**ADDRESS: 305 N FRONT ST**

Proposal: Renovate building; rebuild facades; add deck and pilot house

Review Requested: Final Approval

Staff Contact: Megan Cross Schmitt, [megan.schmitt@phila.gov](mailto:megan.schmitt@phila.gov), 215-686-7660

WEST EXTERIOR  
ELEVATION

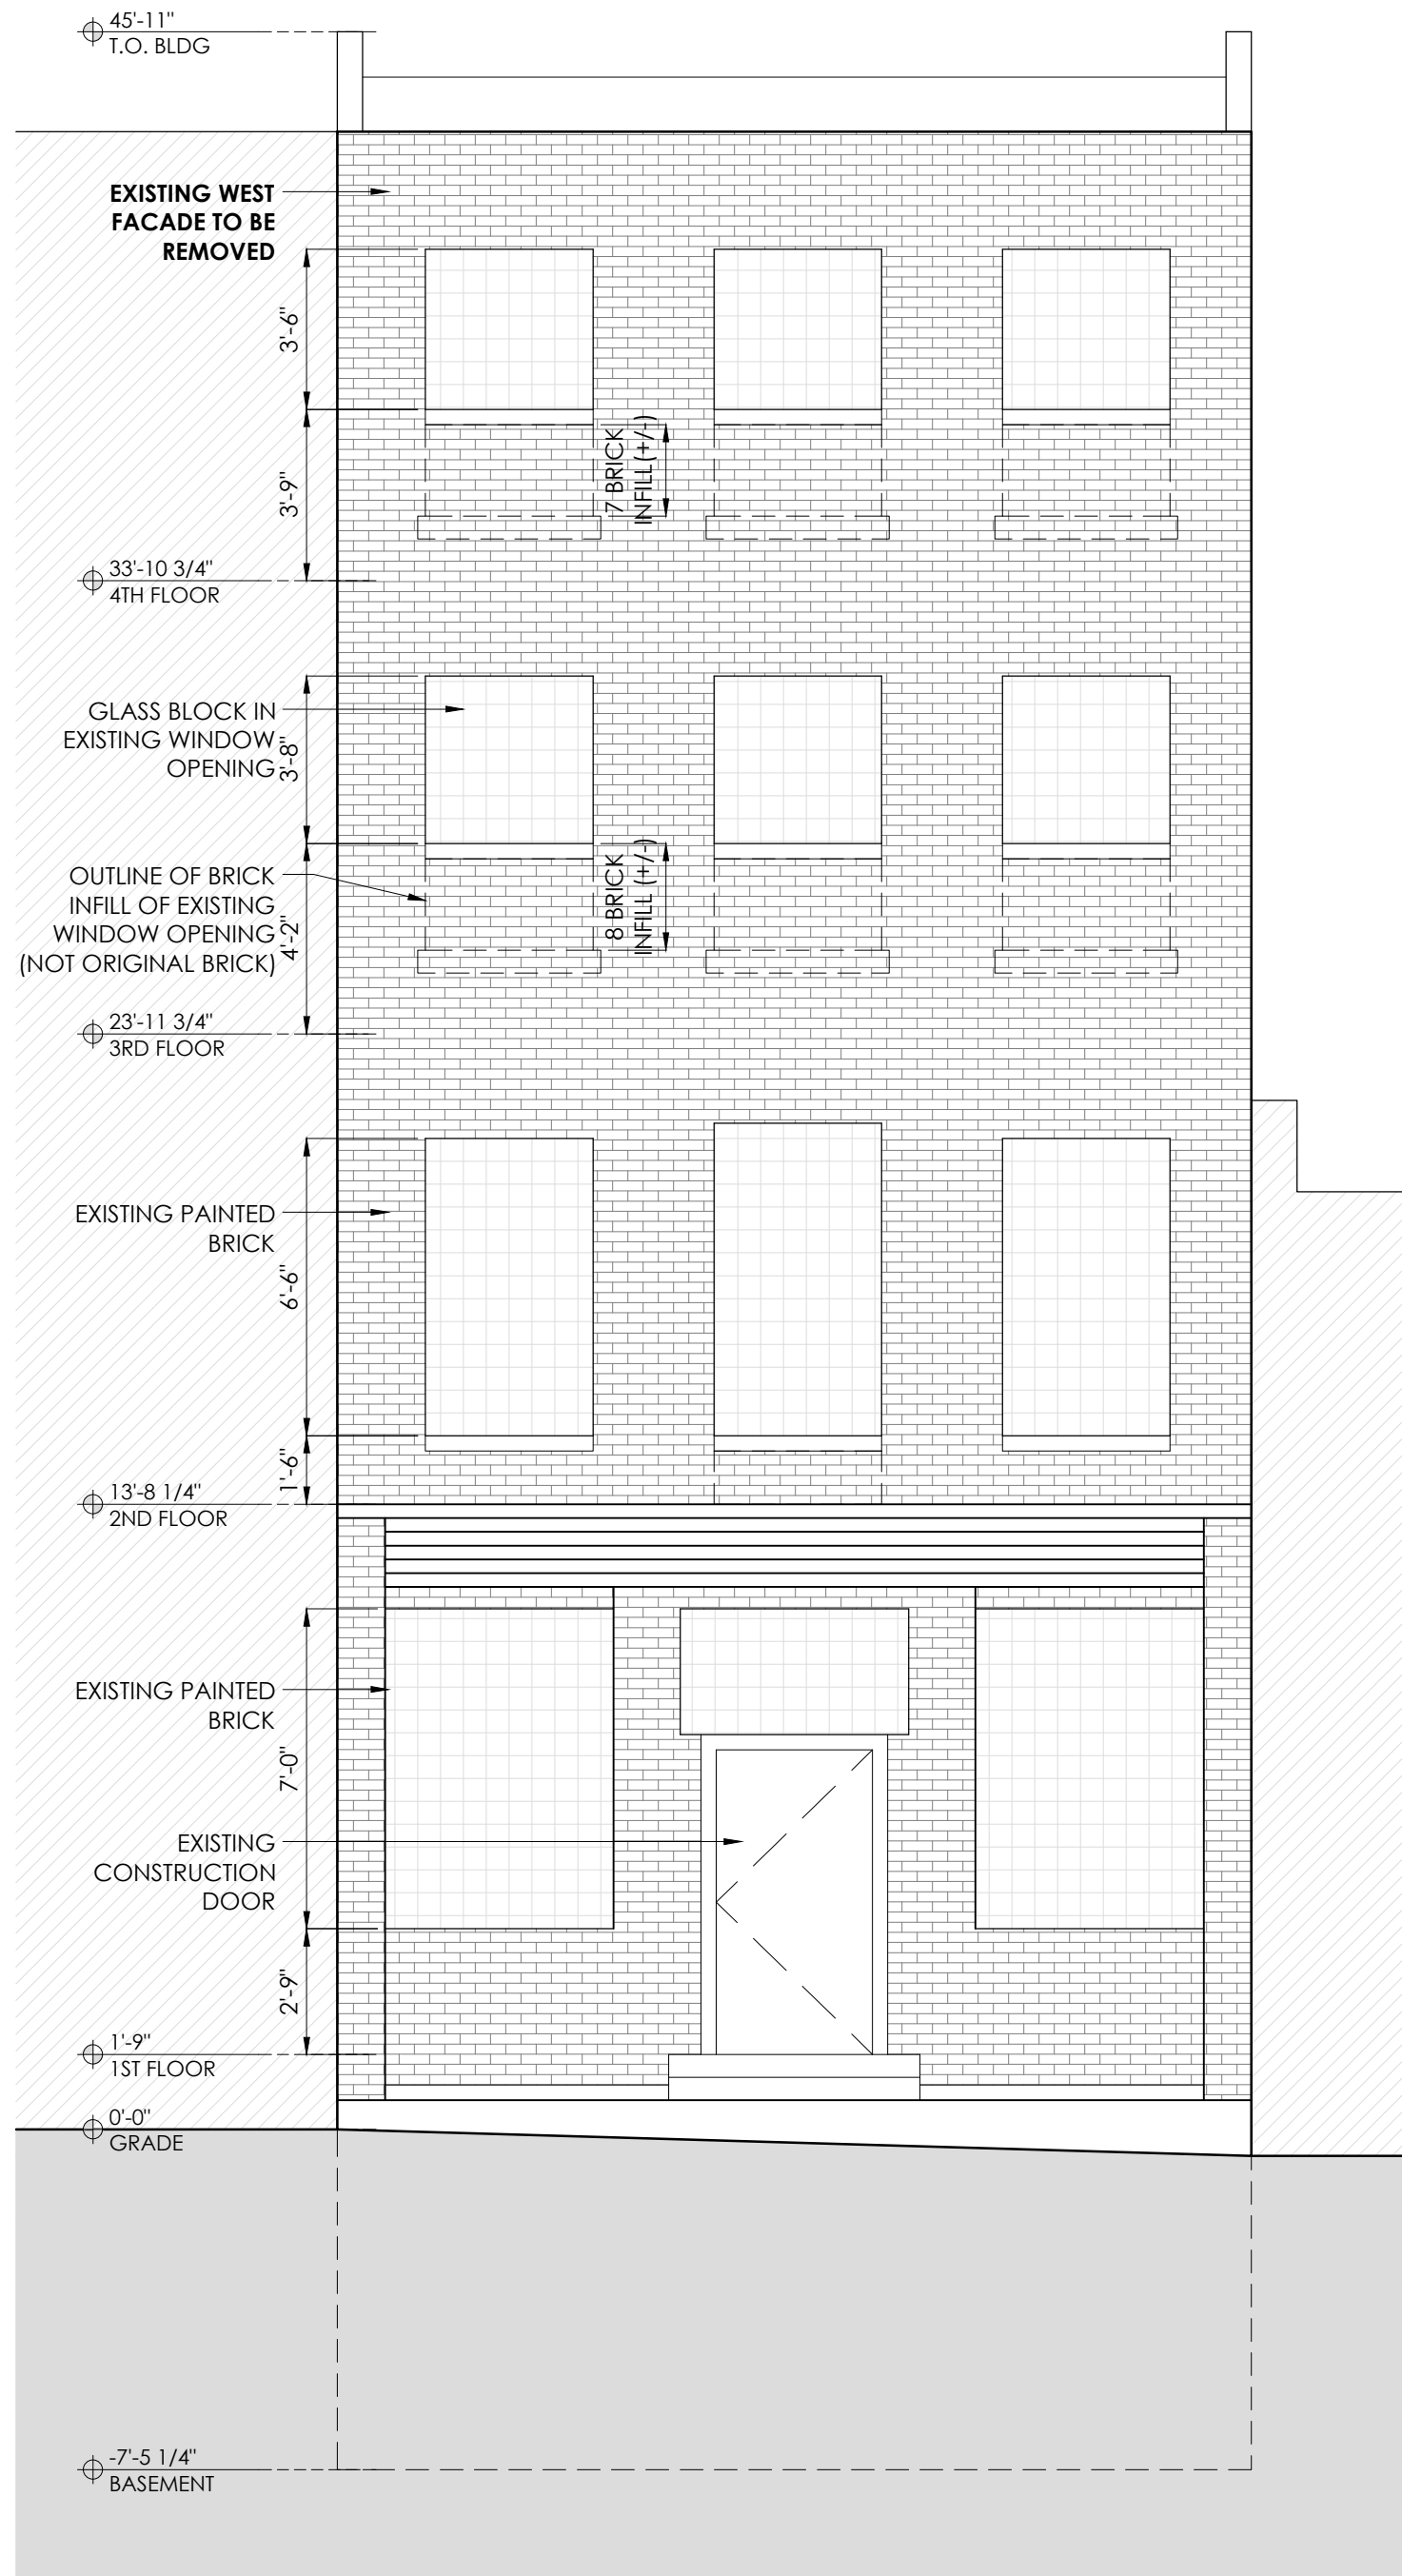
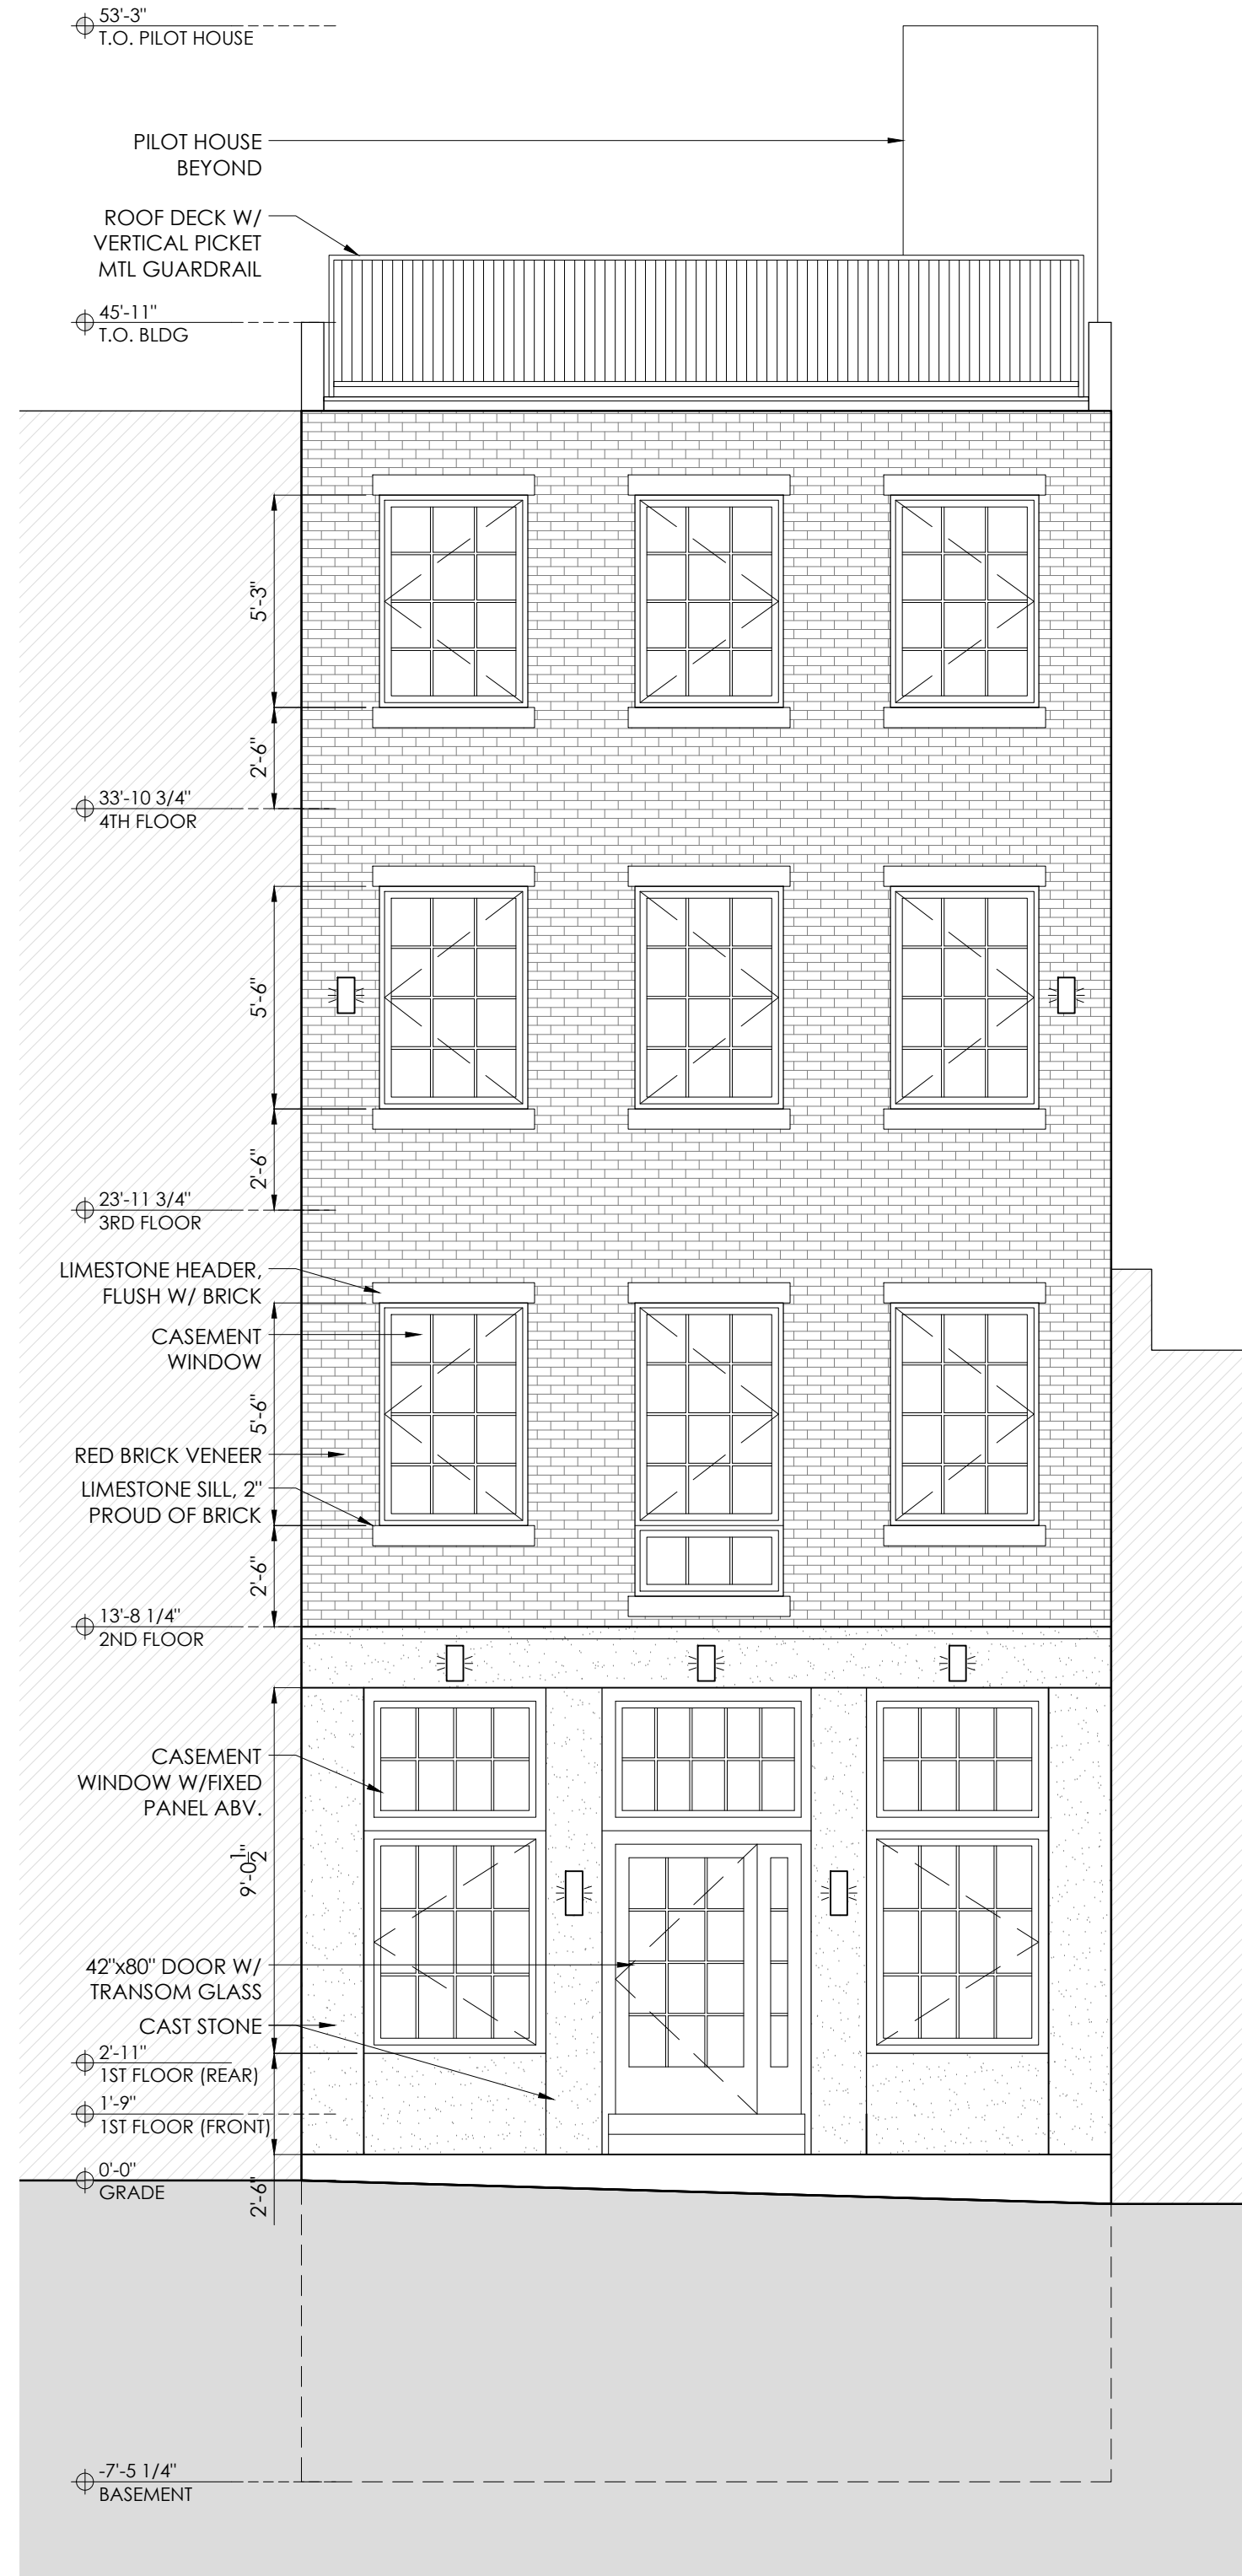
The applicant now proposes a fenestration pattern at the N. Front Street façade that appears to replicate the locations of the original windows. Casement windows are proposed using a simulated divided lite pattern that attempts to approximate a six-over-six, double-hung window, the original window type. Sills and headers would be limestone.

- The extent of the historic brick that is proposed for demolition does not satisfy Standard 9.
- Any historic storefront material that exists beneath the altered N. Front Street façade should be preserved and restored.
- The proposed reconstruction does not reflect existing physical and archival evidence of the building's historic conditions. Given the availability of such evidence, the proposed reconstruction should more closely reflect the historic facades in terms of fenestration, window type, and façade materials.
